Re: Design Exception #DE25-05 – Shadow Run at the Ridges – Path Width

## DESIGN EXCEPTION #DE 25-05

RE: Shadow Run at the Ridges – Path Width

# Design Exception

### Proposed Design:

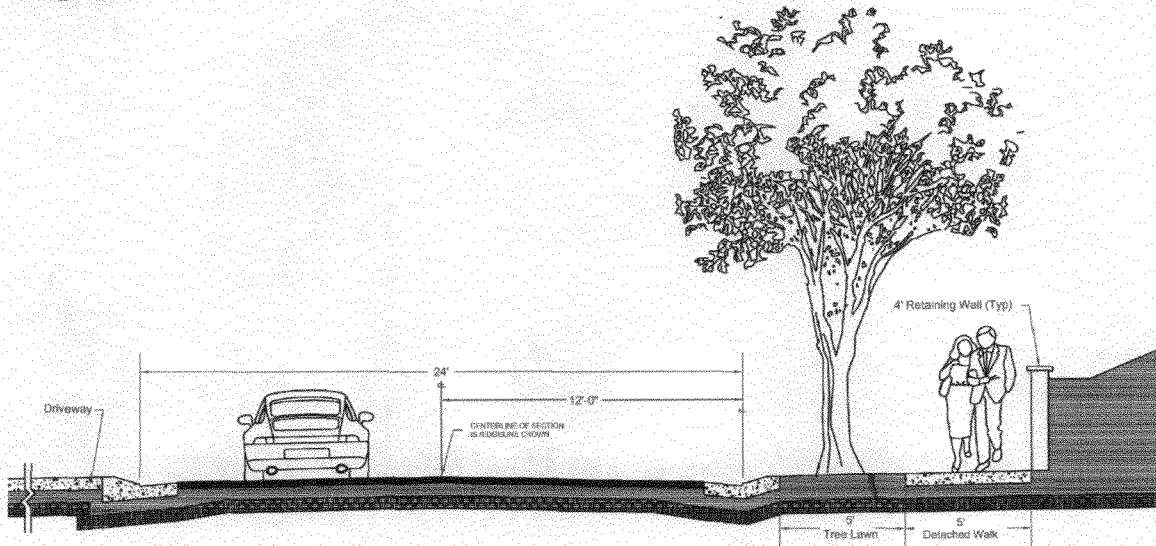
It is the applicant's vision to include a 5' wide detached walk along the outside perimeter of Cliff View Drive in order to promote pedestrian connectivity between Shadow Run and Plateau Drive. *The proposed streets and walk are private* and meet or exceed all other aspects of TEDS private road standards. The walk is to be constructed by the developer, and privately maintained by Shadow Run's Home Owners Association.

Proposing the detached walk at 5' width will allow less grading on this steep site. It will result in less disturbance and retaining walls during construction which will help preserve the natural integrity of the site.

Proposed Street Section

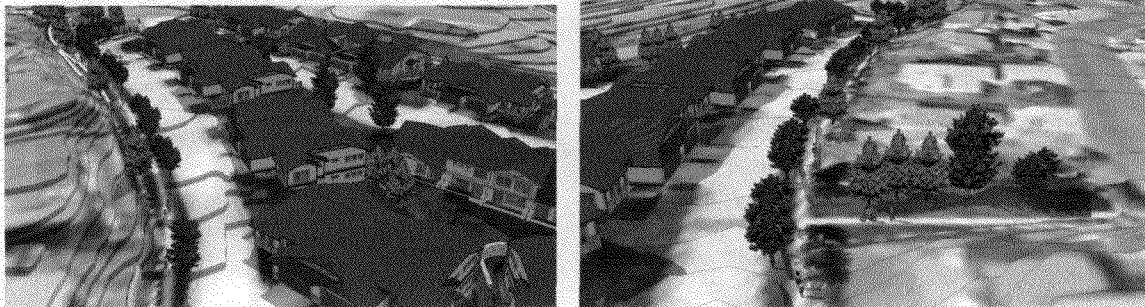
The walk however is not a regional trail and is strictly facilitating pedestrian connectivity between neighborhoods, therefore we feel a conventional 5' width is adequate to meet the intent of TEDS.

Utilizing a 5' detached walk, as opposed to an attached side walk provides more separation from the road, and the ability to add a landscaped tree lawn, buffering vehicular from pedestrian use. In this regard, the detached walk is safer, adding distance and separation between cars and walkers. This landscape buffer adds aesthetic value to the streetscape, and the neighborhood.

Staff does not believe the detached 5' walk will compromise pedestrian safety.

Staff recommends approval of the exceptions as proposed.

- If granted, will the exception compromise safety?
  - o No.
- Have other alternatives been considered that would meet current standards?
  - o Yes. It is possible to attach the walk to the private road, which would meet the apparent requirement in TEDS for private streets. However, there is no additional value in applying the attached walk to this project. The safety, aesthetic, and overall quality would be negatively impacted if the applicant is forced to attach the walk to the street.

- o It is also possible to widen the walk to 10' wide, as required by TEDS. The 10' concrete two-way bike/ped path is the only "standard" that the City currently has, and is appropriately used as large, regional paths constructed in public parks and along heavily used pedestrian/bike corridors. However, use of this standard width in this project would greatly increase the grading impacts, and seems out of place for a project that will only serve to provide a "shortcut" from an existing neighborhood to an existing public street.
